Date: January 16, 2018

From: Lisa Pedrini, Senior Planner

Subject: Major Development Permit Application (DPA008)
Development Variance Permit Application (DVP118)
1422, 1426, 1430 Portage Road (Crestline)

Figure 1: Site Plan

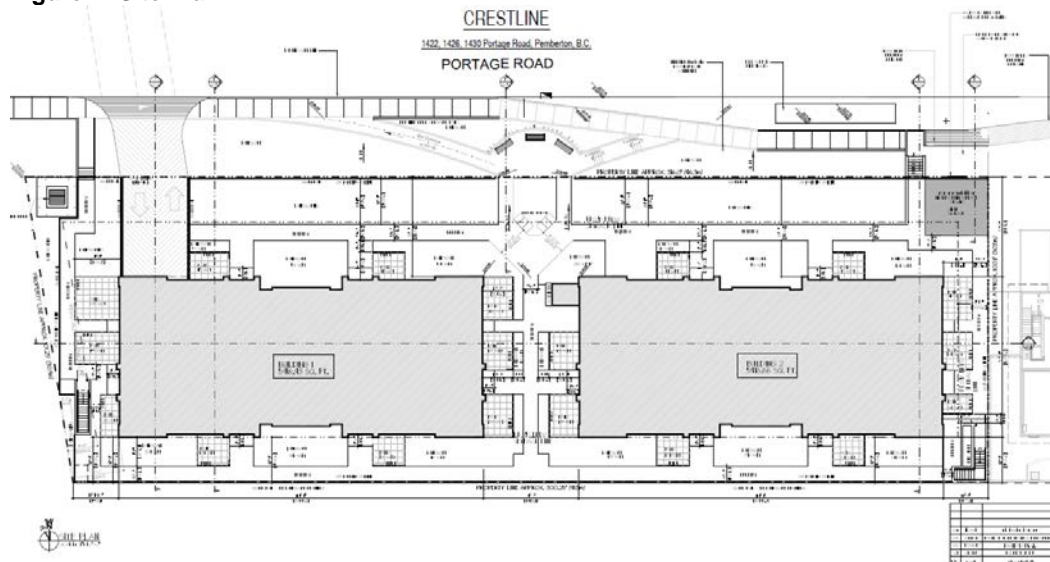
Staff Comments: The applicants have indicated the location of a new fire hydrant to be installed near the north east corner of the development shown on their revised site plan submitted November 22, 2017.

- **Garbage/ Recycling Area** - MOTI has concerns about the location of the Garbage/Recycle area at the northeast corner of the property. If this site requires a service vehicle to access within the proposed loading bay, it may be in conflict with the access to/from the neighboring property.

- **Pedestrian Infrastructure & Landscaping** – MOTI acknowledges that the building structure has been moved further away from the road right-of-way, and would like to see the proposed pedestrian access and seating area moved back as well in order to reduce encroachment into MOTI's setback.

- **Access** - The plan indicates three (3) pedestrian accesses; two (2) stairs and one (1) ramp and could illuminate one (1) set of stairs. The area on road right-of-way between the development and the back of municipal sidewalk could still be landscaped, under permit. Reducing the infrastructure will also reduce the possible hardship should the Ministry's future needs impact this area.

Staff Comments: The applicant is aware of this concern and will work with MOTI to mitigate the potential conflict in sightlines. Approval from MOTI will be a condition of DP issuance.

Staff Comments: The applicant has been informed of MOTI's wishes and is willing to adjust the site plan to suit. Staff will ensure that this request is

Staff Comments: The applicant requires a permit from MOTI to place pedestrian access structures within their right of way setback. Approval from MOTI will be a condition of DP Issuance.

Figure 3: Landscape Plan

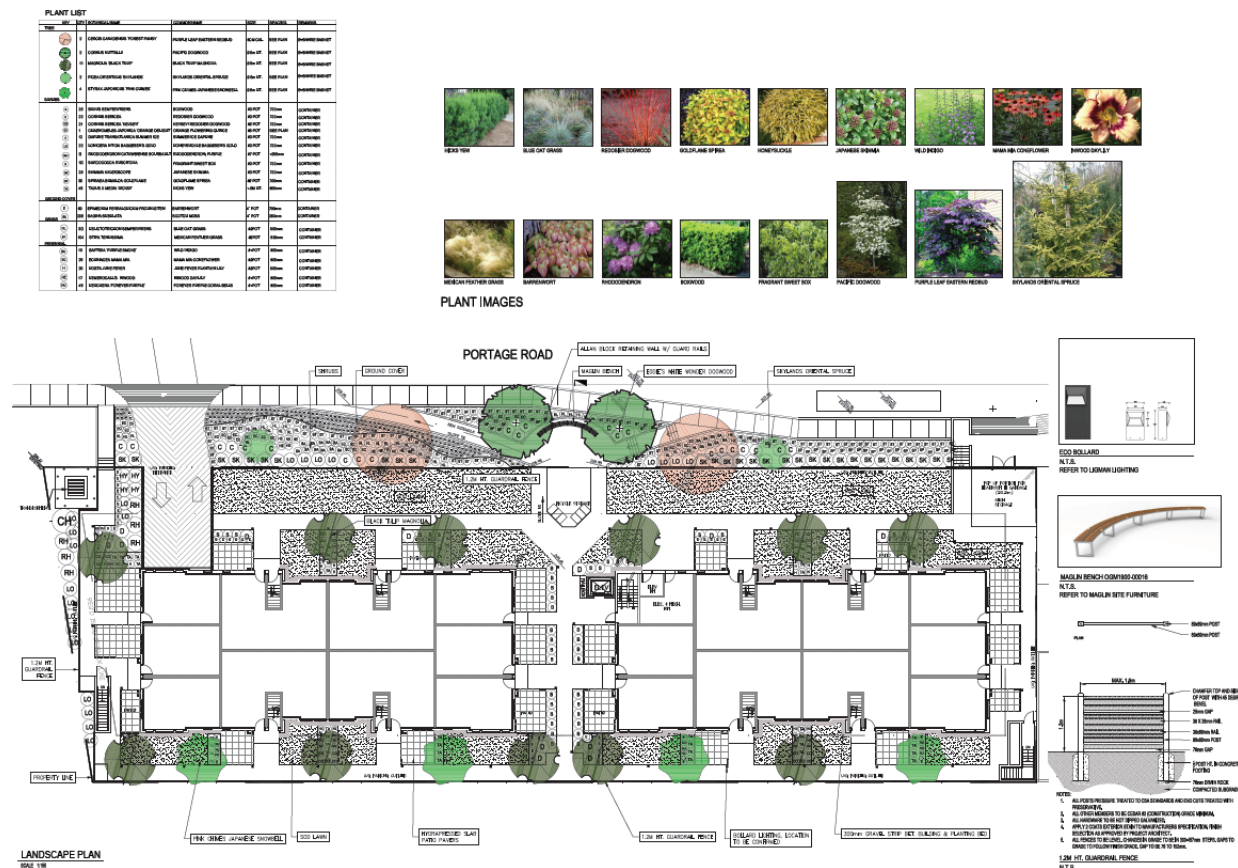
Discussion among the ADRC took place respecting the need to establish landscaping or screening to hide the pad-mounted transformer (PMT) located in the north/west corner of the property. The proponents advised that they are waiting referral comments from BC Hydro with respect to options for screening and/or landscaping. It is the intention that the PMT will be hidden from view.

The ADRC also suggested enhancement of the space between Portage Station (concrete wall) and Crestline on the east side of the building. The proponents advised that they would look at addressing this through their landscaping plan. They were also advised to address accessibility concerns with respect to the bench (seating area) located at the front of the property by adding back and arm rests.

- *Screening of the PMT (north/west corner),*
- *Creeping evergreen plantings in the north/east side of the building to cover the pop up garbage enclosure,*
- *Adding accessibility components (back and arm rests) to the bench located at the front of the property along the walkway.*

Figure 6: Streetscape Elevation Comparison between New Design and Old Design

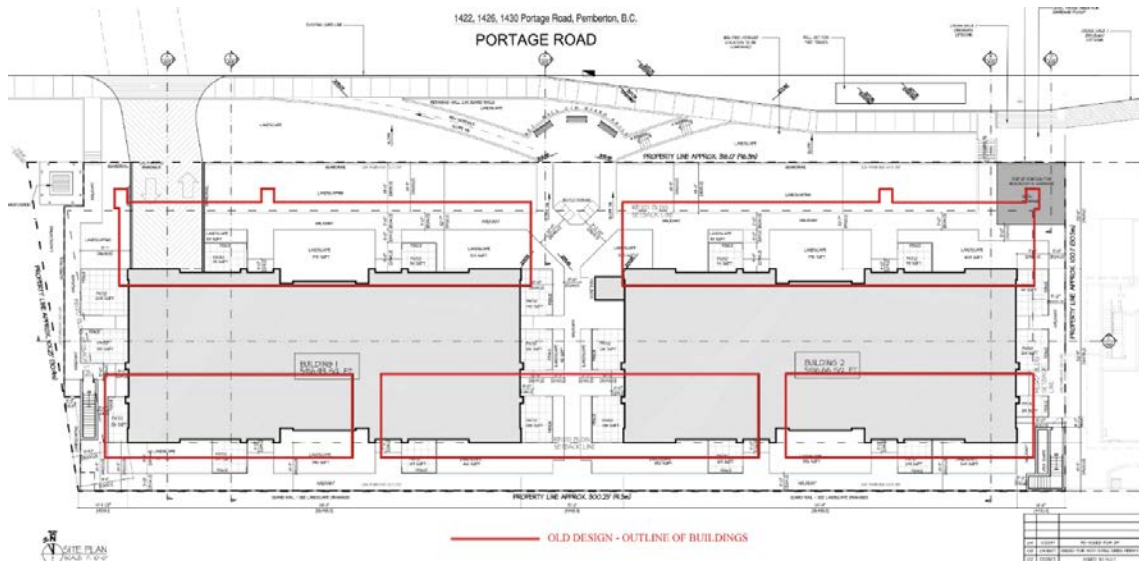
- The number of buildings on the site have been reduced to two (2) from five (5) and old design/new design comparisons were presented.
- The height of the building has been reduced while maintaining the Flood Construction Level requirements and it is now the same height as Portage Station next door.
- The buildings have been pushed back considerably from the front setback, but they will still require a Variance from both the Ministry of Transportation & Infrastructure and the Village of Pemberton.
- The new renderings provided a better view of what the building will look like from both the east and west side directions.
